January 2023
FL959AB
NHTSA #22V-840

Subject: TBB Minotour Barrier Configuration

Models Affected: Specific model years 2021-2023 TBB Minotour school buses manufactured June 3, 2020, through July 19, 2022.

Fig. 2, Location of the Reinforcement

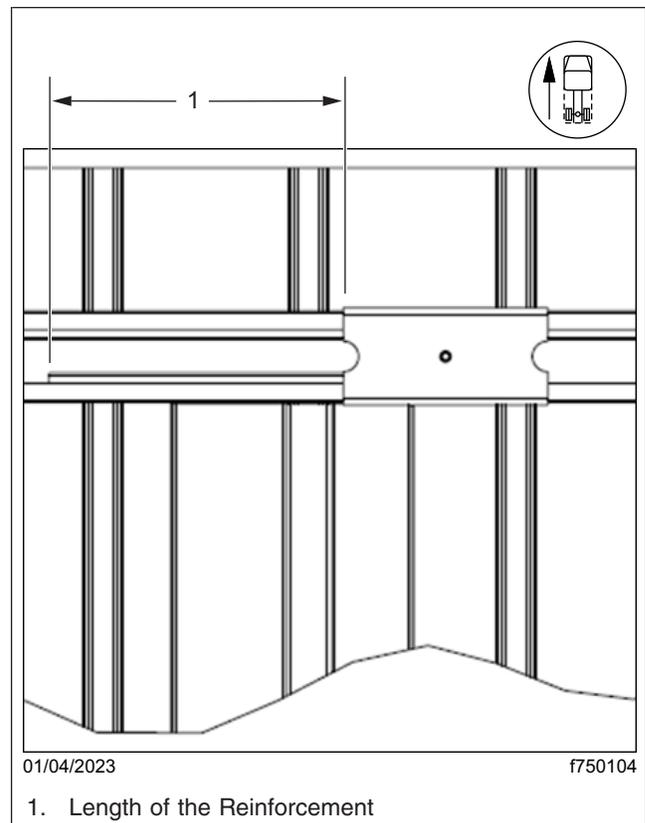
1. Park the vehicle on a level surface, shut down the engine, and set the parking brake. Chock the tires.
2. Disconnect the negative battery cables at the batteries.
3. Remove the existing barrier. **Do not** discard the fasteners, they will be used during install.
4. Install the joist reinforcement (205873). See [Fig. 1](#).

[Figure 2](#) shows the precise location of the reinforcement installation.

6. Install four self-tapping screws (69003250) in the pilot holes to hold the joist reinforcement in place.
7. Install the new barrier as per the new seat plan. For detailed instructions, see **Drawing 214356** (reference **Drawings 214355** and **151775**).
8. Connect the negative battery cables at the batteries.

Fig. 4, Location of the Reinforcement

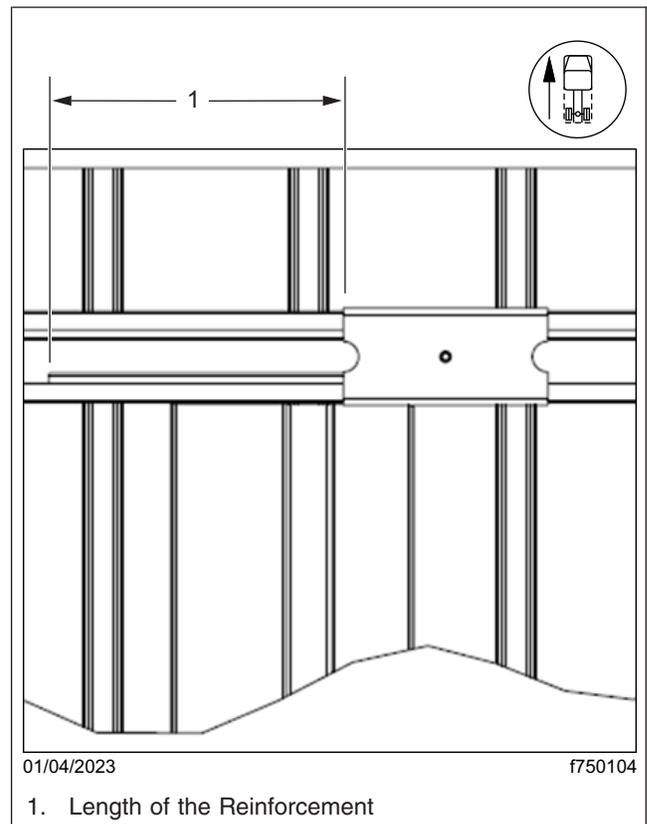
1. Park the vehicle on a level surface, shut down the engine, and set the parking brake. Chock the tires.
2. Disconnect the negative battery cables at the batteries.
3. To discuss vehicle configuration per VIN, and for guidance on seat repositioning, contact the Customer Assistance Center at (855) 639-8686, from 8 a.m. to 5 p.m. Eastern Time, Monday through Friday.
4. Remove the existing barrier. **Do not** discard the fasteners, they will be used during install.
5. Install the joist reinforcement (205873). See [Fig. 3](#).

[Figure 4](#) shows the precise location of the reinforcement.

6. Use a #20 (or 5/32-inch) drill bit to drill four pilot holes in the underside floor joist.
